Dominion Nuclear Connecticut, Inc.
Millstone Power Station
Rope Ferry Road
Waterford, CT 06385

Millstone Nuclear Power Station, Unit Nos. 1, 2 and 3
Request for Approval of a Change In the Frequency of Review of the
Quality Assurance Program by the Independent Review Team and
Annual Reporting of Changes to the Quality Assurance Program
Revision 24 to the Dominion Nuclear Connecticut, Inc.
Quality Assurance Program Topical Report - Millstone Power Station

Summary of Changes

<p><u>Figures 1.0, 1.1 and 1.2</u></p> <ul style="list-style-type: none"> • Figure 1.0, 1.1. and 1.2 were modified to reflect the organizational changes described above. Offsite

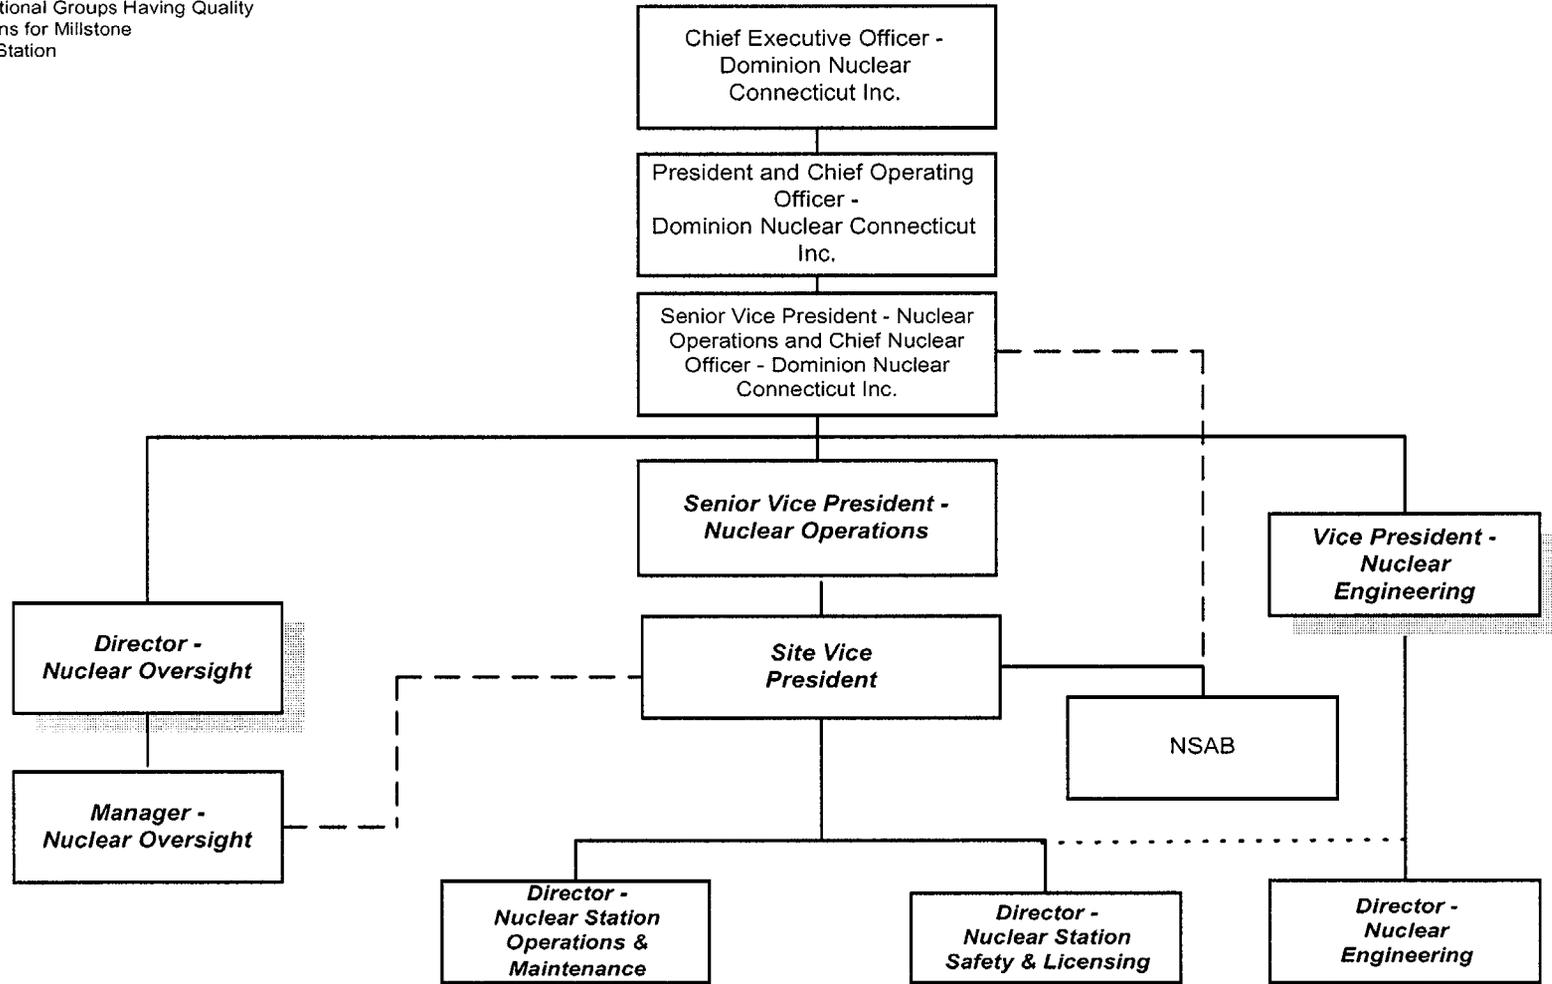
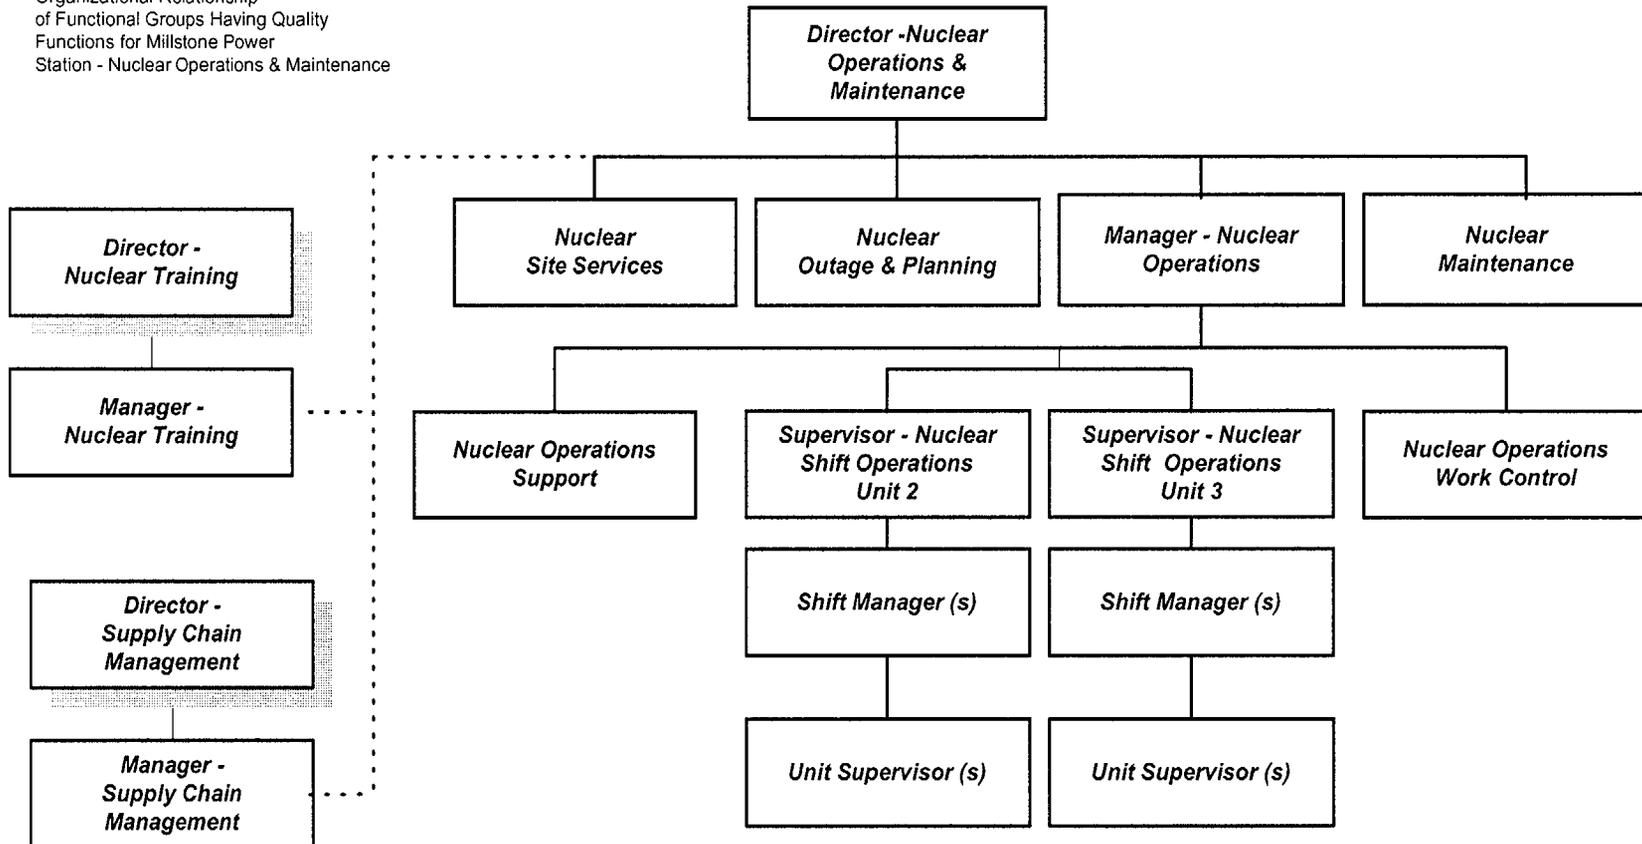
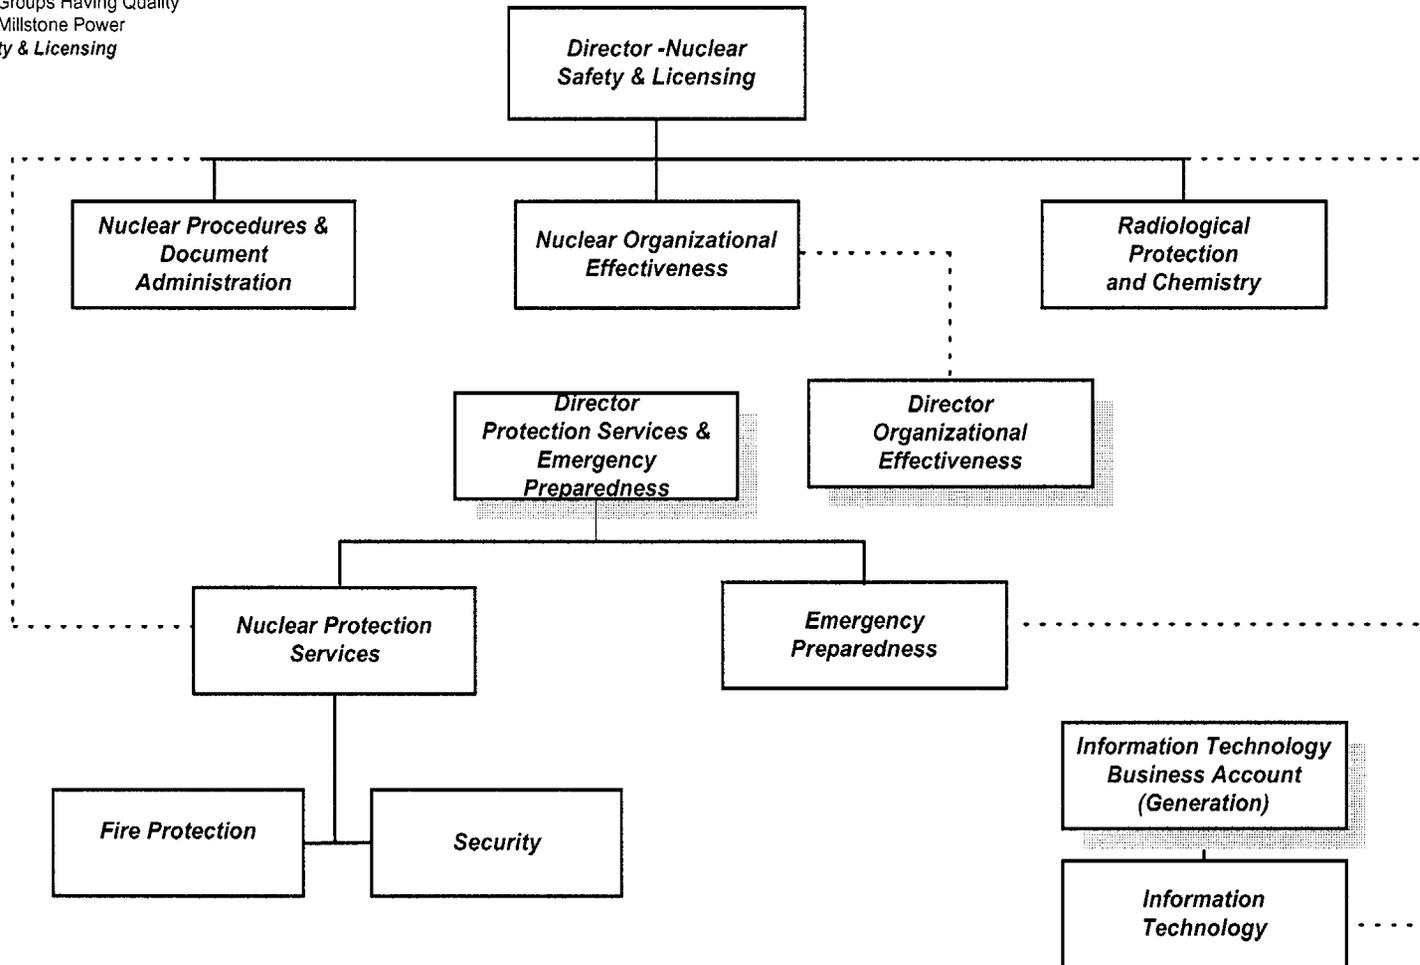
<u>Section</u>	<u>Summary Description of Changes</u>
	<p>positions/organizations are shadowed and matrixed relationships are indicated with a dotted line.</p> <ul style="list-style-type: none"> • Figure 1.0, Title change for "Vice President and Senior Nuclear Executive - Millstone" to "Senior Vice President - Nuclear Operations".
QAP 2.0	<ul style="list-style-type: none"> • Modified organization and titles to be consistent with Dominion Corporate and North Anna and Surry Stations, (more traditional instead of process based) and realigned Millstone Station organization to be consistent with the Dominion Corporate and North Anna and Surry Stations organization, reporting to one Site VP, and several off-site organizations as described above in changes to QAP 1.0. • Realigned Millstone Nuclear Oversight to report to Corporate Nuclear Oversight Director.
QAP 3.0	<ul style="list-style-type: none"> • Modified Titles/Department Names to be in alignment with Dominion Corporate and North Anna and Surry Stations (more traditional instead of process based, therefore "Manage the Asset" is changed to "Nuclear Engineering").
